# PRODUCT UPDATE

#176

## Single Piece Earthing Crown and Retaining Ring For 00, 0B/0S, 1B/1S and 2B/2S Couplers and Fixed Receptacles

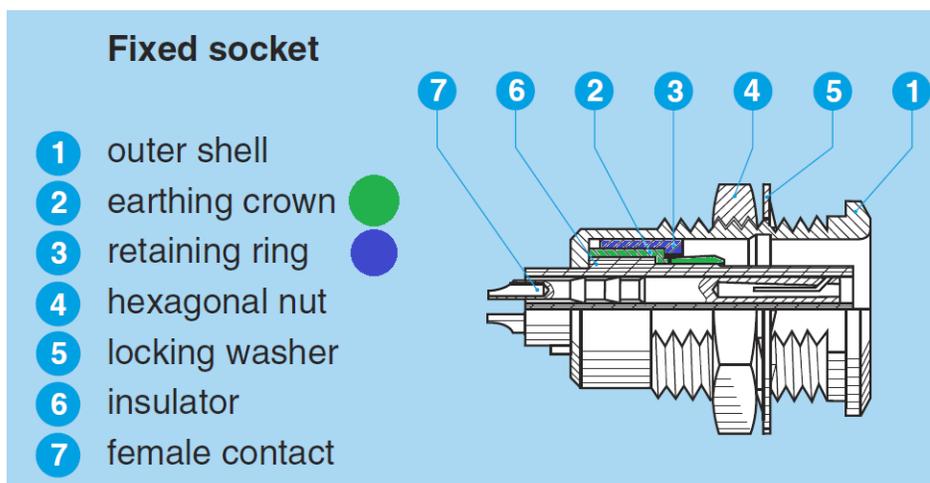
Items 2 and 3 in the below example fixed socket sketch will now be made with a single piece. The materials and plating will be the same. Sizes affected are 00, 0B/0S, 1B/1S and 2B/2S.

The Earthing Crown and Retaining Ring for the “E” prefix sockets, “R” and “S” prefix couplers will now be manufactured as a single piece rather than two separate pieces due to internal improvements to LEMO’s high quality processes and procedures. There is no change to the fit or function of this new piece.
